***Environmental Protection Act 1986*****Section 43A****NOTICE OF DECISION TO CONSENT TO AMEND A REFERRED PROPOSAL  
DURING ASSESSMENT****PERSON TO WHOM THIS NOTICE IS GIVEN**

Karara Iron Ore Project – Mine Life Extension  
Assessment No. 2369

Figure 1 – Proposed Development Envelope and Disturbance Footprint (area of disturbance) as referred versus as amended following s43A changes

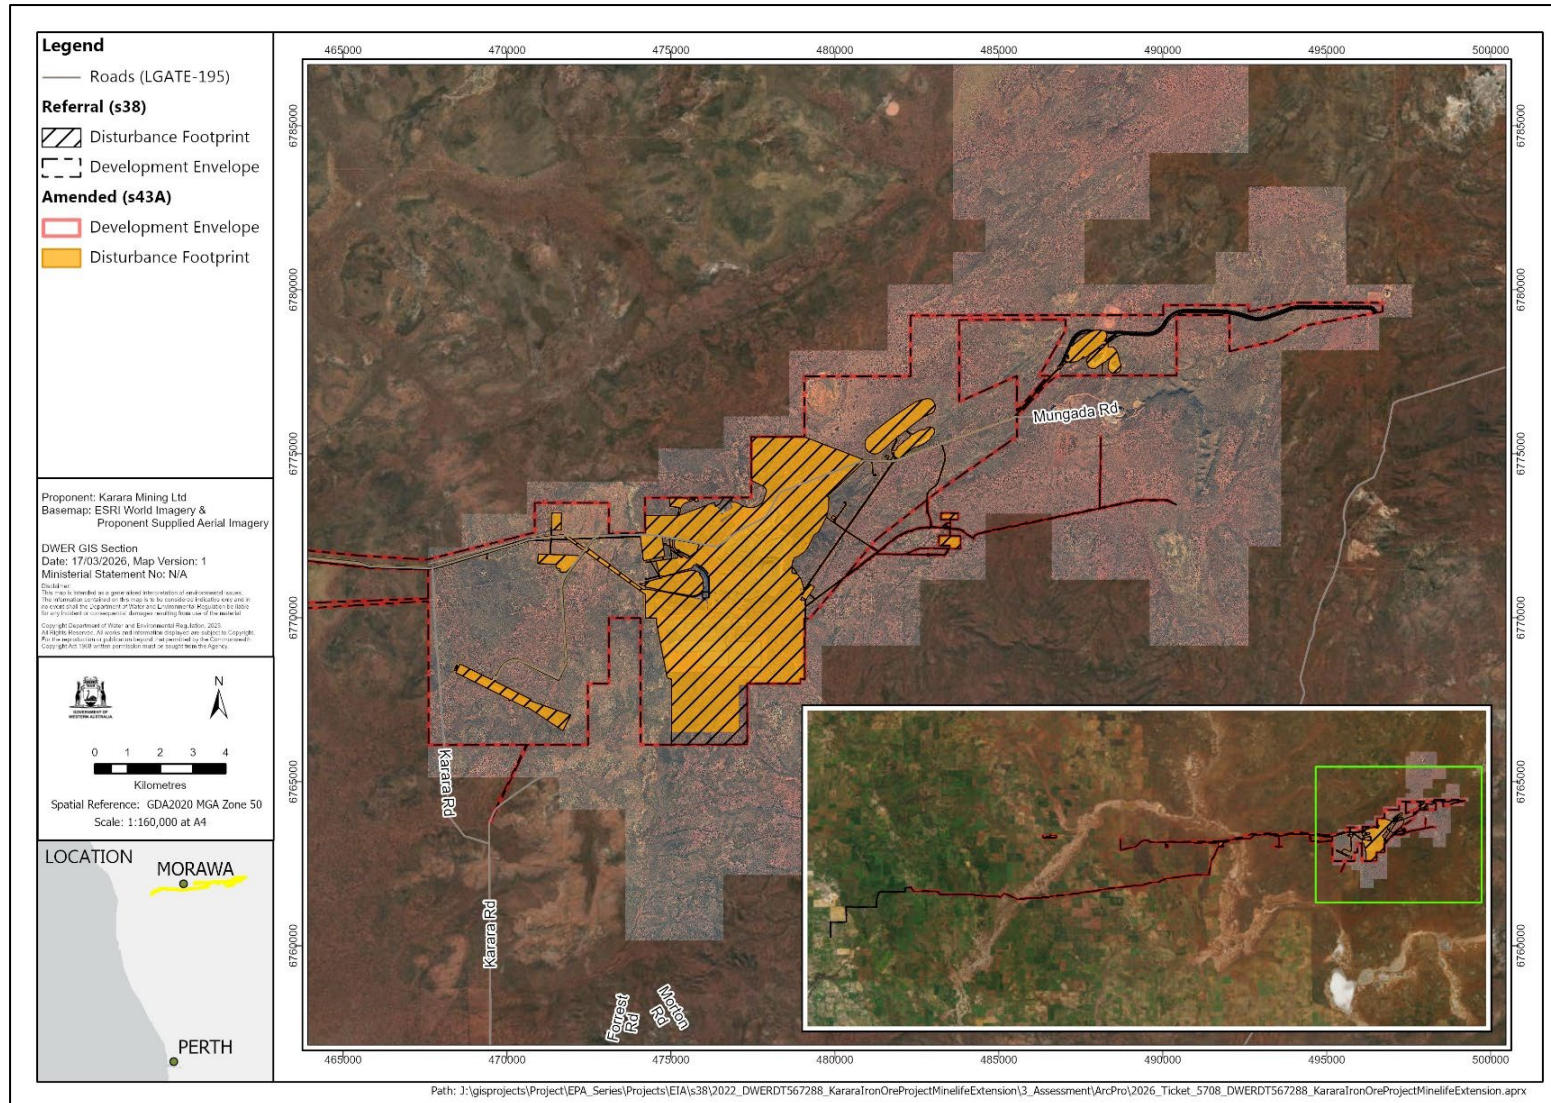
- Reduce the proposed development envelope by 76 hectares (ha) to 13,481 ha and reduce the proposed area of disturbance by 342 ha to 4,698 ha (Figures 1 & 2). This includes:

- revising the proposed disturbance breakdown for the waste rock dump, tailings storage facility and site infrastructure
  - removing maintenance areas for existing infrastructure previously approved through clearing permits under Part V of the EP Act.

- The amendment involves a net reduction of both the development envelope and disturbance area to reduce impacts to significant flora and vegetation values including *Lepidosperma* sp. Blue Hills (Priority 1) and *Caesia* sp. Koolanooka Hills (Priority 1).

<b>Physical elements</b>					
Development envelope	Not defined.	Not defined.	<u>Combined KIOP &amp; MIOP:</u> Up to 13,557 ha as shown in Figure 1.	Reduced by 76 ha.	<u>Combined KIOP &amp; MIOP:</u> Up to 13,481 ha as shown in Figure 1.
Area of disturbance	Approx 3,027 ha. <ul style="list-style-type: none"> <li>• Mine – approx. 2,336 ha;</li> <li>• LIC – approx. 384 ha; and</li> </ul> Access Road – approx. 308 ha.	Approx 1,059.35 ha comprising: <ul style="list-style-type: none"> <li>• pits and waste dumps – 290 ha;</li> <li>• infrastructure – 224 ha;</li> <li>• haul road – 257.35 ha;</li> <li>• gravel pits – 110 ha;</li> <li>• powerline corridor – 67 ha; and</li> <li>• rail siding – 111 ha.</li> </ul>	<u>Combined KIOP &amp; MIOP:</u> Up to 5,040 ha (indicative disturbance footprint shown in Figure 1).	Net reduction of 342 ha as shown in Figure 2.	<u>Combined KIOP &amp; MIOP:</u> Up to 4,698 ha (indicative disturbance footprint shown in Figure 1).
